Lakeshore Transportation Studies from Winston Churchill Boulevard to Etobicoke Creek

New Credit River Active Transportation Bridge Study

**Public Feedback Report from Credit River Active Transportation Bridge
Design Workshop held May 3, 2022, and Online Survey available from April
26 to May 10, 2022**

Figure 7 – Lighting Considerations

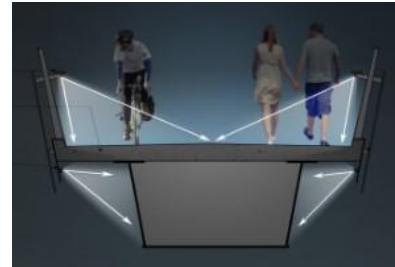
#	Comment/Question Noted	Response
1	Imagine lighting can be finalized later. Darkness is important in Memorial Park West for shore fishing at night, viewing night sky (hard to do in GTA, and enjoying	<i>Response from Bridge Design Architect:</i> I would just reiterate that you're absolutely right that it's important not to overdo the lighting to really aim it and shield it so that it just highlights the structure and doesn't spill into

#	Comment/Question Noted	Response
	the glow of lighthouse beacon on the rippling water. More of a comment, but can lighting not compete with the lighthouse, or be too bright? Internal lighting seems good.	the sky or water. These days with all of the LED fixtures and shields that are available you can do a very nice job of both functional and accent lighting in very tight, restricted angles – so we absolutely can achieve that.

Figure 11 – Viewing Opportunities and Places to Sit

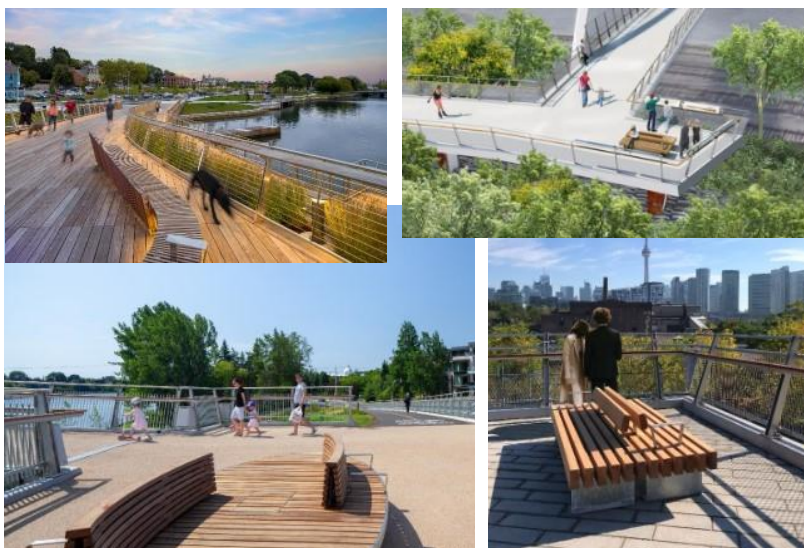
#	Comment/Question Noted	Response
1	Can the bridge be designed to have a lookout on the north and on the south?	<i>Response from Bridge Design Architect:</i> This can be looked at in detailed design.
2	With the rail bridge close by, how are the sightlines looking north up the river?	<i>Response from Bridge Design Architect:</i> There are beautiful views up the valley and up the river, so I think we can't just pretend that all the nice views are to the south, so this is something that could be looked at.
3	Can one lookout be at the north, another at the south	<i>Response from Bridge Design Architect:</i> This can be looked at in detailed design.

Figure 13 – Interpretive Elements**Experience | Interpretive Elements**

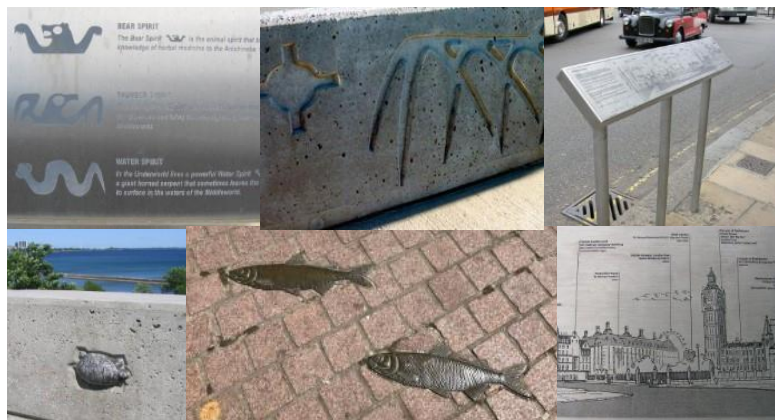
#	Comment/Question Noted	Response
1	Public art / interpretive elements can be added later and would be great community project (re indigenous, etc.). I worry up-front cost of too many add-ons might deter quick budget approval. Basic architecture of truss design is beautiful on its own. Can the costs be broken out?	Response needed.
2	How have Indigenous communities been engaged, as well as the Credit Valley Trail organization? I see this bridge as a key element for	<i>Response from HDR:</i> Indigenous communities have been invited to all public meetings and have been circulated all available Natural Environment and

education/signage on indigenous history and art created by hired and recognized Indigenous artists from the Region.	Archaeological reports. They will also be consulted on the final project report.
--	---	--
